## **Access Compliance Report Public Rights-of-Way** (Curb Ramps)

Intersection ID: 9687 Main Street: N\_PINE\_ST Cross Street: W\_28TH\_ST Location: Ε **Overall Compliance: No** ADA ID: E087CC6D0590 Ramp Type: Perp Initial Pass/Fail: Fail **Severity Score:** 35

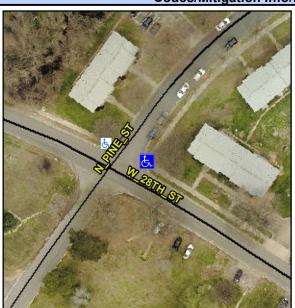
Possible Solutions: Remove & Replace Entire Ramp. Surveyor Notes: N/A PROW/ADA: Not Found, R304.5.1, R304.2.2, R304.5.3

Field Measurements/Component Compliance					
Compliance Description		Data	Comp	liance Description	Data
N/A	Ramp Length (in)	57.0	No	Ramp Slope (%)	12.8
No	Ramp Width (in)	47.0	No	Ramp XSlope (%)	4.9
N/A	Flare Type LT	N/A	N/A	Flare Type RT	N/A
N/A	Flare Slope LT (%)	N/A	N/A	Flare Slope RT (%)	N/A
N/A	Flare Traversable LT?	N/A	N/A	Flare Traversable RT?	N/A
N/A	Landing Length (in)	N/A	N/A	DWS Provided?	N/A
N/A	Landing Width (in)	N/A	N/A	DWS Contrast?	N/A
N/A	Landing Slope (%)	N/A	N/A	DWS Length (in)	N/A
N/A	Landing X Slope (%)	N/A	N/A	DWS Full Width?	N/A
N/A	Landing Curb? (Y/N)	N/A	N/A	DWS Offset (in)	N/A
N/A	Shared Landing?	N/A			
N/A	Gutter Ponding?	N/A	N/A	Gutter Slope (%)	N/A
N/A	Gutter Lip Ht (in)	N/A	N/A	Gutter X Slope (%)	N/A
N/A	Painted X Walk1?	No	N/A	Painted X Walk2?	N/A
	X Walk 1 Direction	To NW		X Walk 2 Direction	N/A
N/A	X Walk 1 Width (in)	N/A	N/A	X Walk 2 Width (in)	N/A
	X Walk 1 Slope (%)	1.1		X Walk 2 Slope (%)	N/A
